81-103 King's Road

Welcome to our second round of Community Meet and Greet events.

As previously noted during the last round of consultation events held in May, the design team have undertaken a review of the consented scheme, alongside supporting information including the fire strategy, and new survey information. This review has resulted in the team identifying several minor amendments that will be required to deliver the consented building.

Proposed Amendments

Roof - Proposed

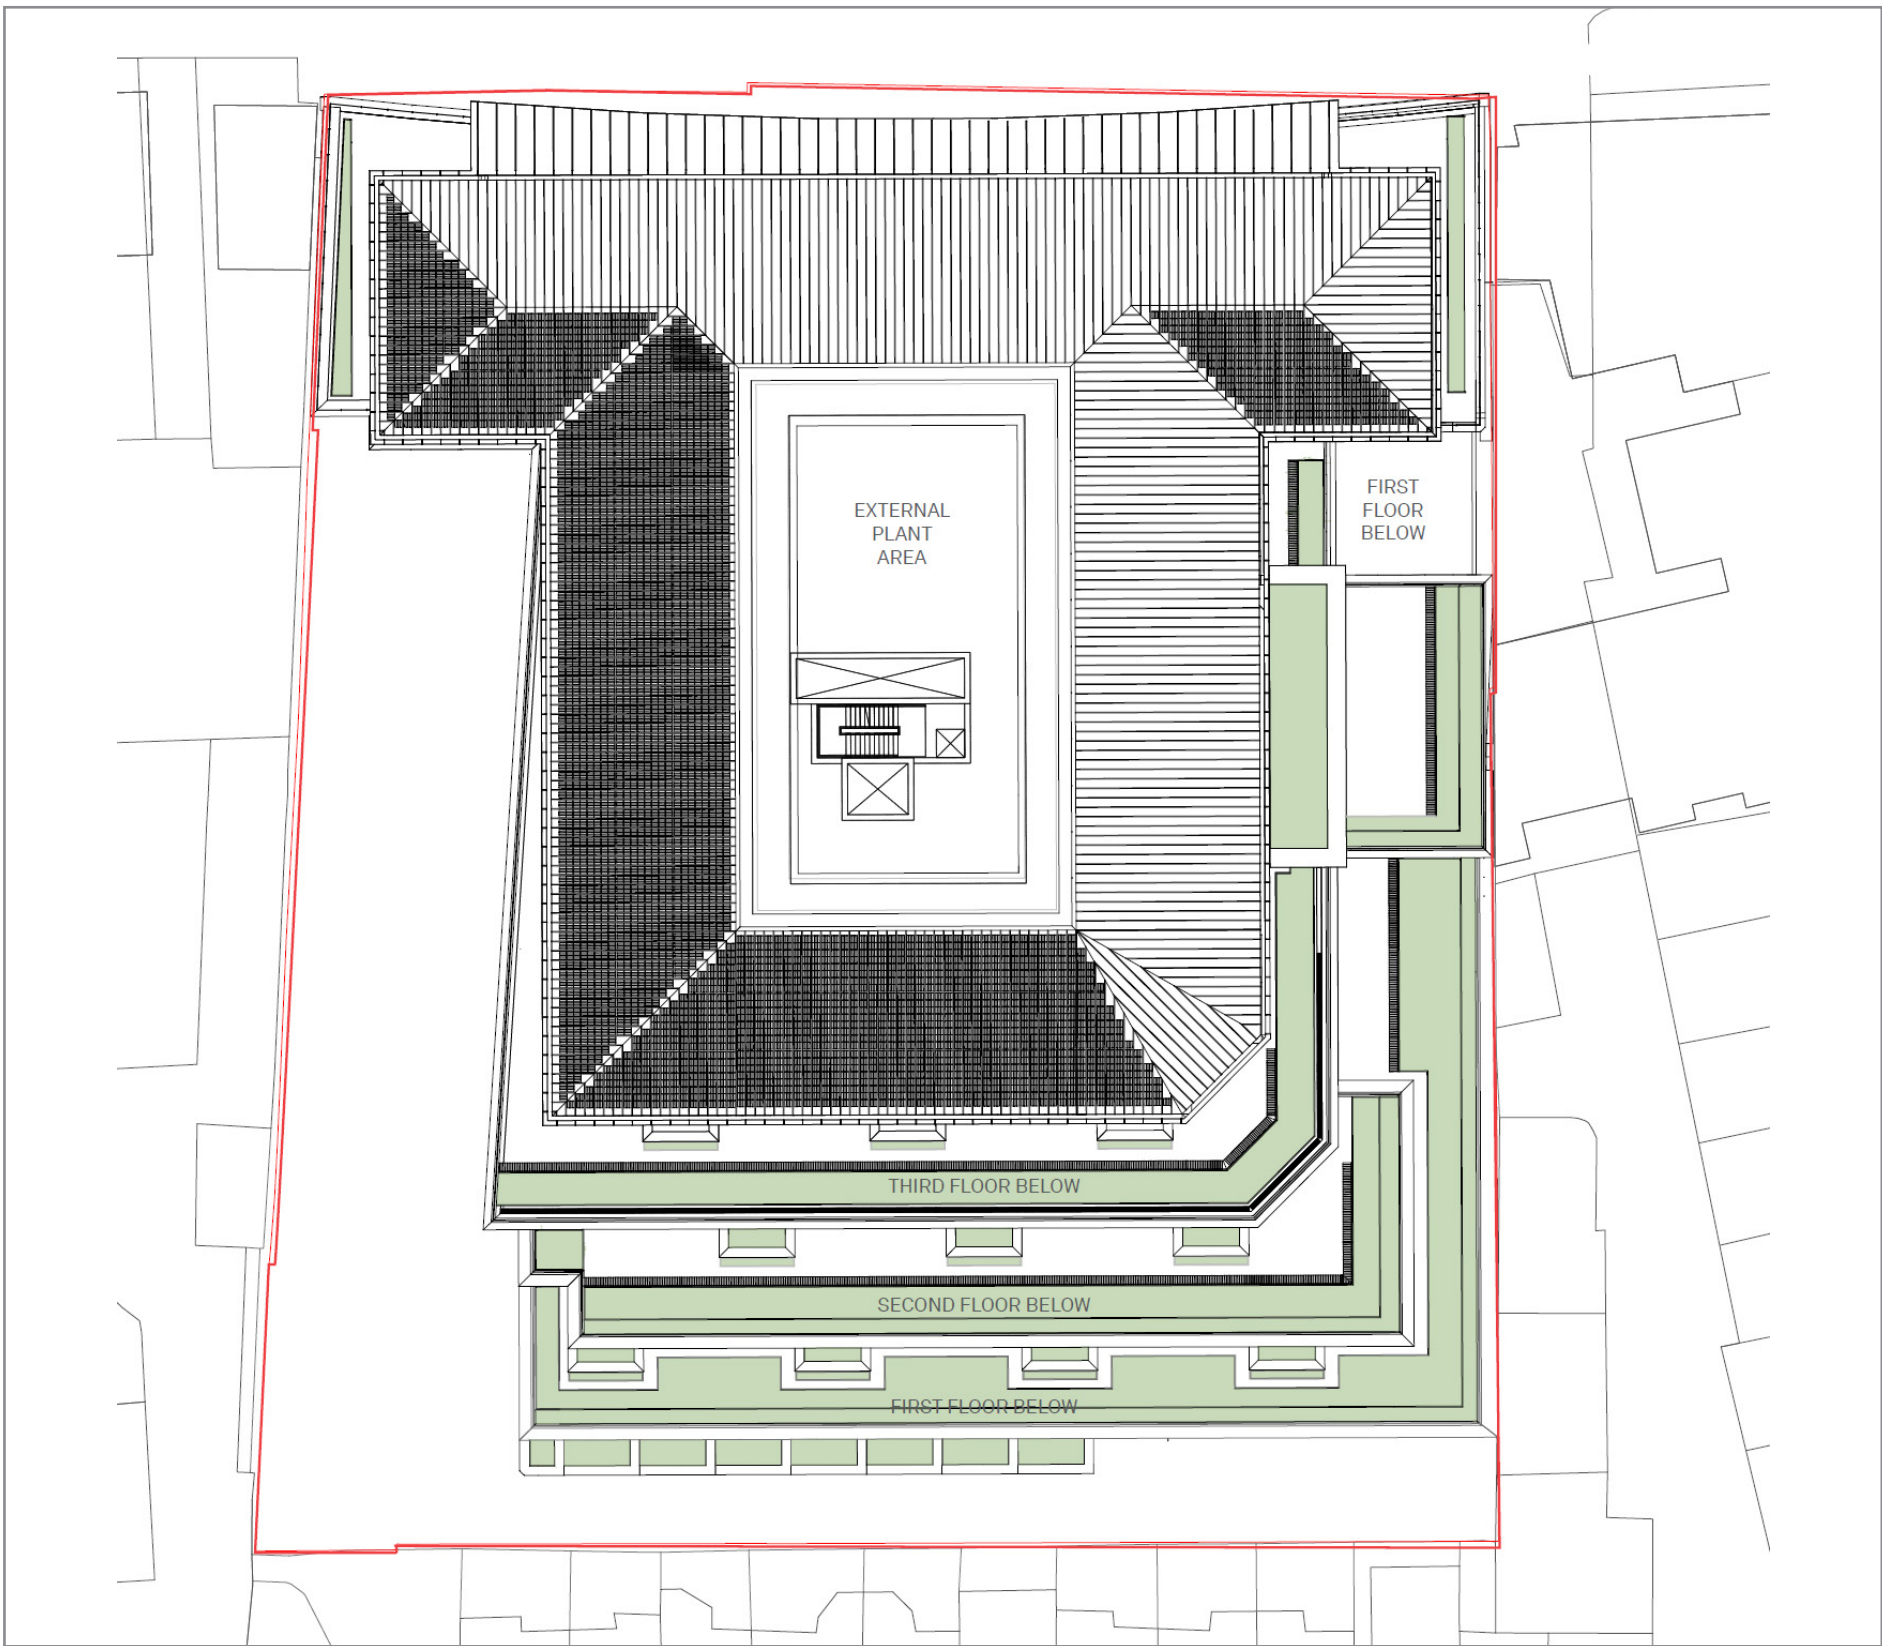
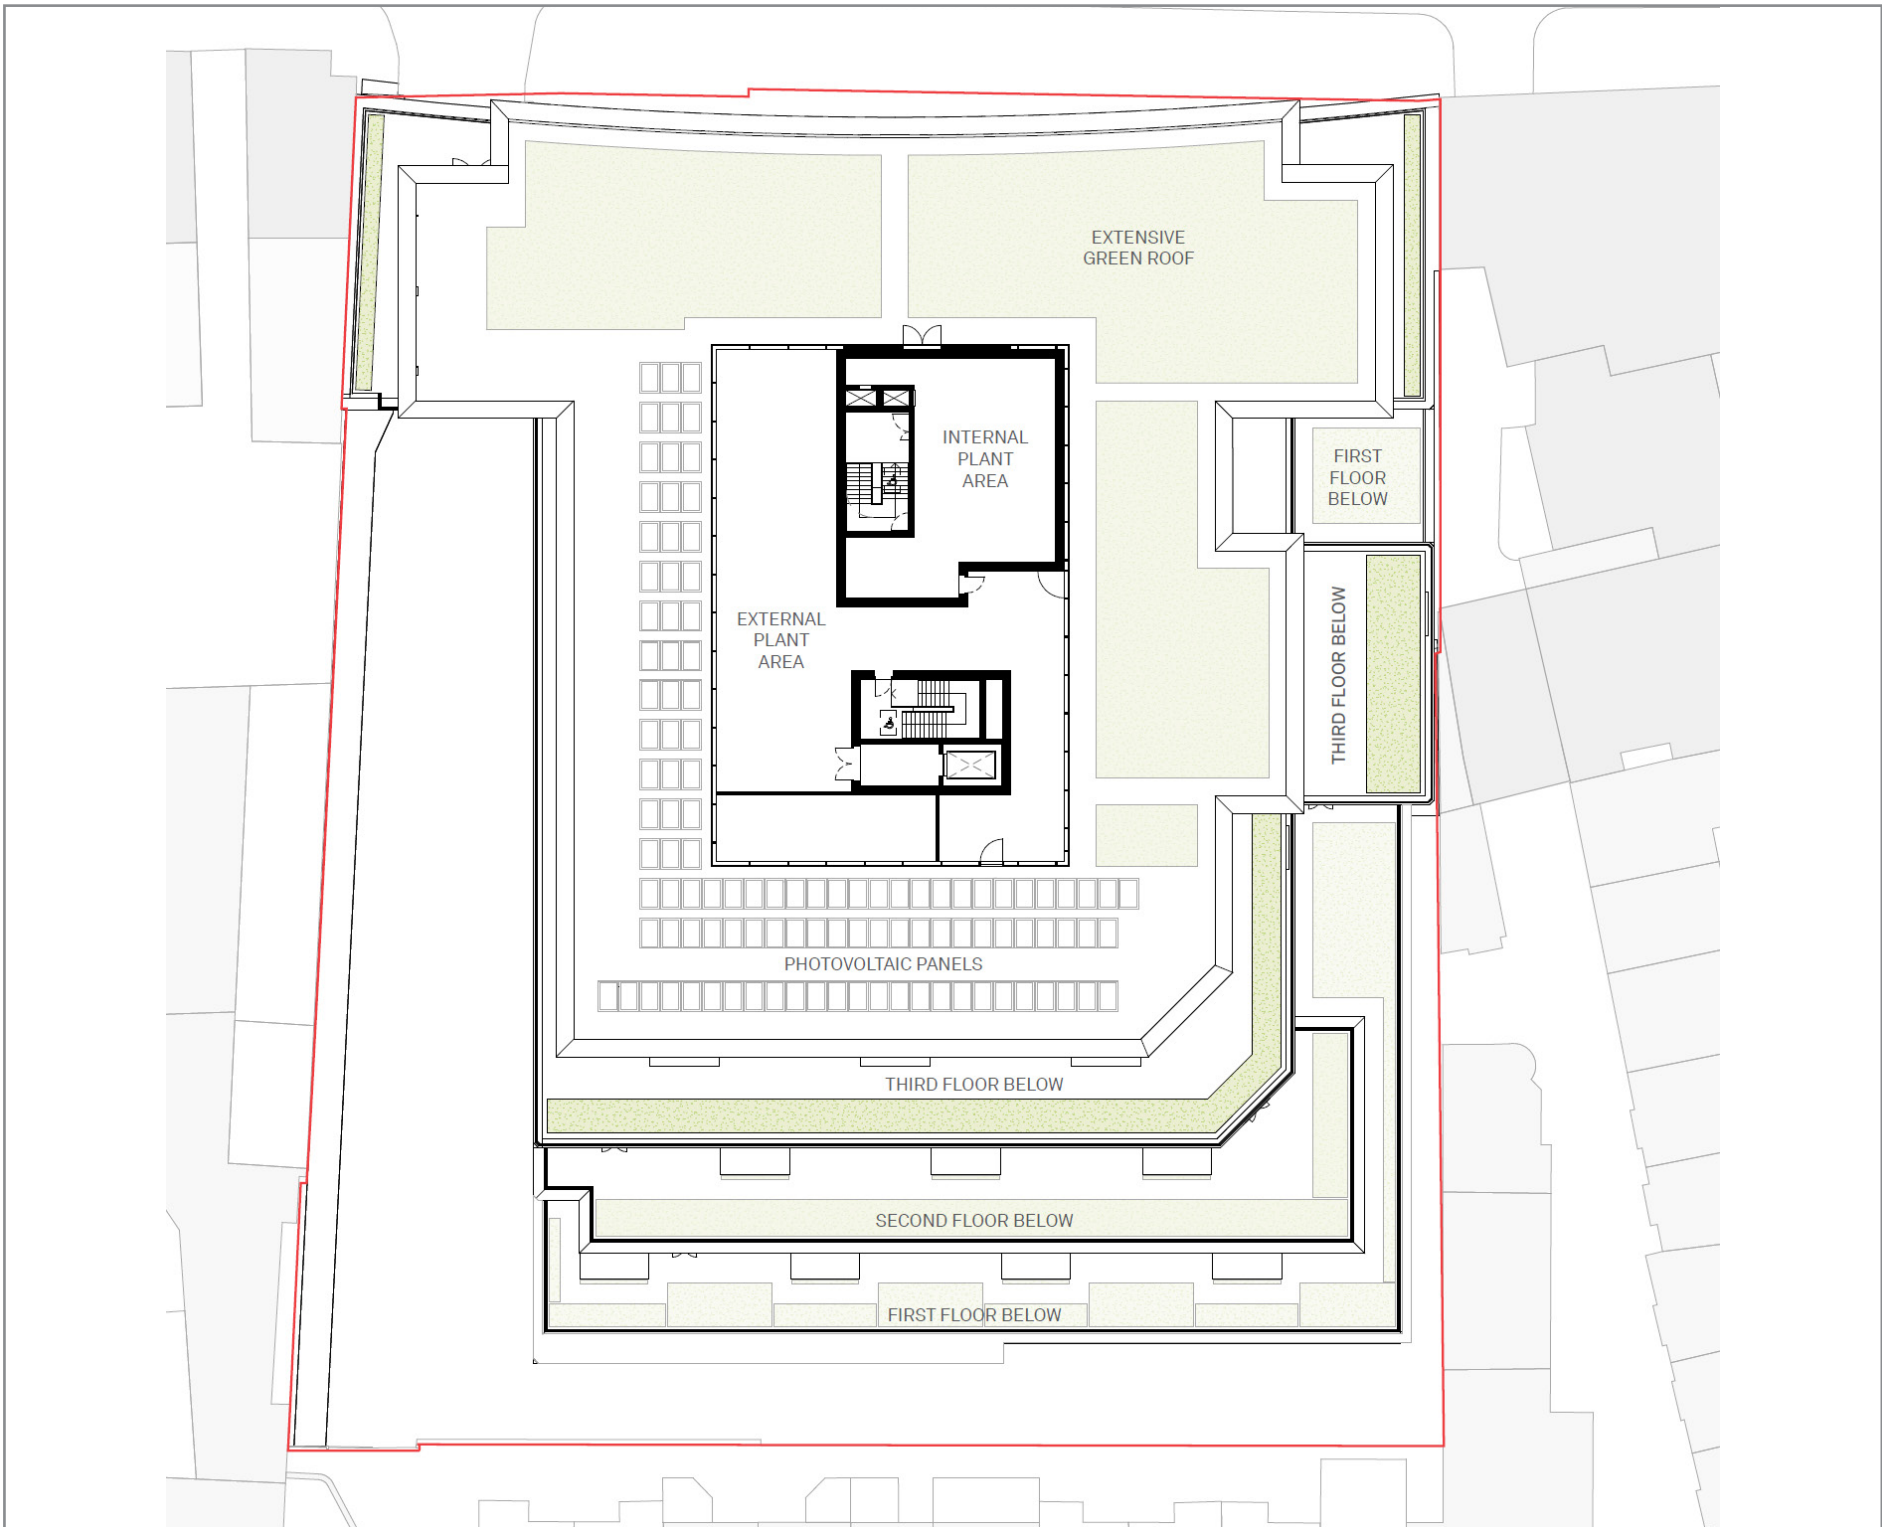
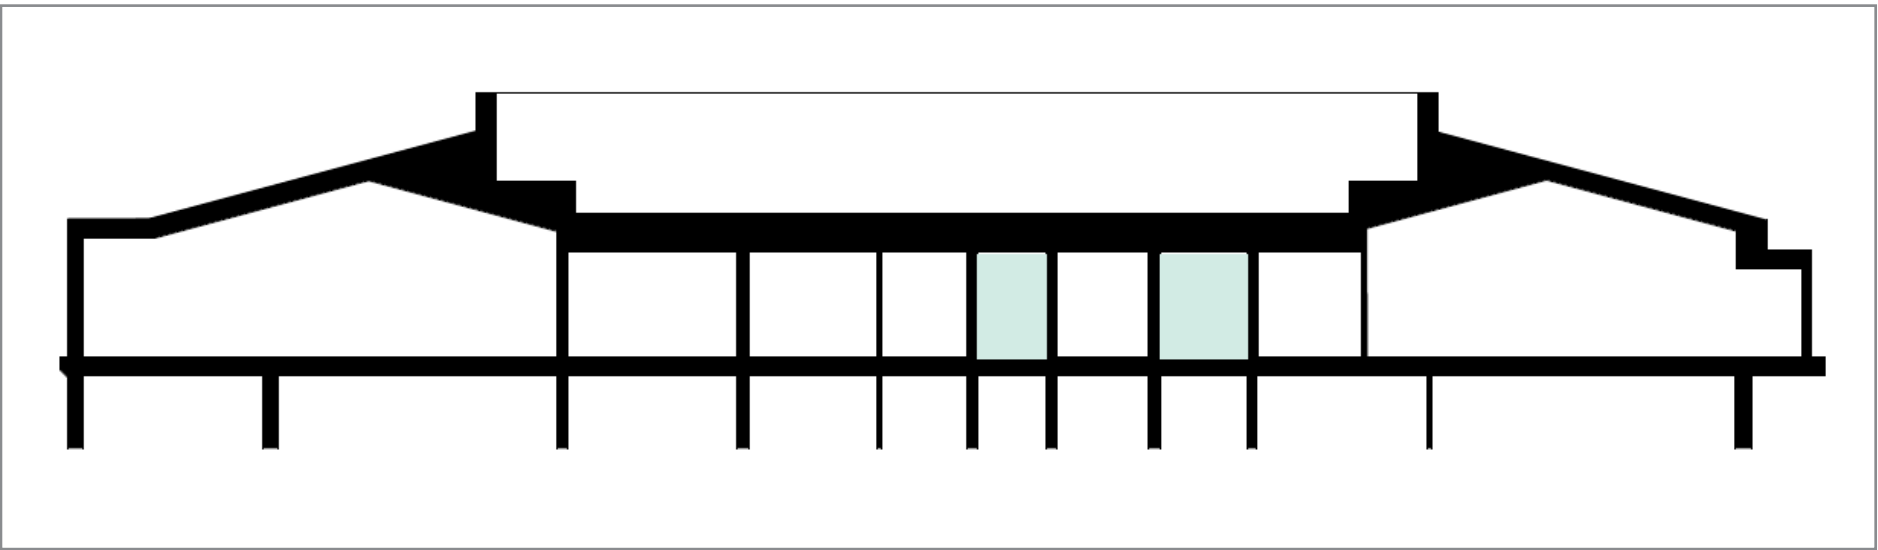
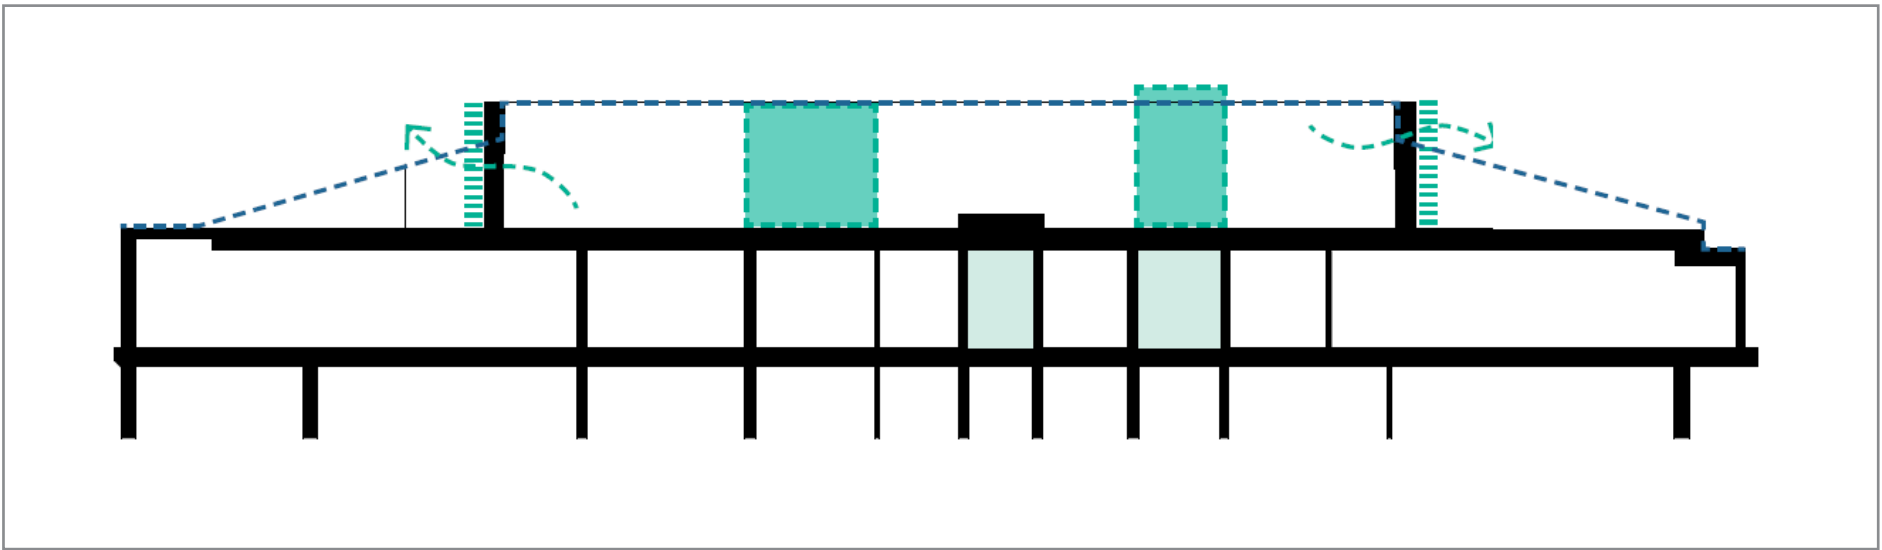
The proposal involves altering the plant enclosure design to ensure free airflow for the rooftop plant as required for proper mechanical function, with full height acoustic louvres being installed around the perimeter. The plant screen enclosure becomes slightly wider, but no higher.

To facilitate this, the structural design of the roof will change from timber to a flat slab post-tensioned concrete system with columns added at the third floor (this is consistent with the structure throughout the rest of the building, so is also efficient from a programme perspective).

A key mitigation measure to reduce impact on basement and rooftop spaces involves moving away from a centralised MEP solution to an on-floor ceiling solution. This reduces the quantity of plant otherwise required at roof level, and so allows basement plant that is too tall to fit within the basement space to be accommodated at roof level.

The proposed flat roof now allows for installation of traditional PV panels which are much higher efficiency and higher output for a given area than the previously approved roof-bonded panels. The flat roof also allows for further urban greening to be achieved through the delivery of a green roof.

The goods lift and second stair will be extended to serve the roof to provide safe access for plant replacement and maintenance (without necessitating the future use of mobile cranes parked on Kings Road).
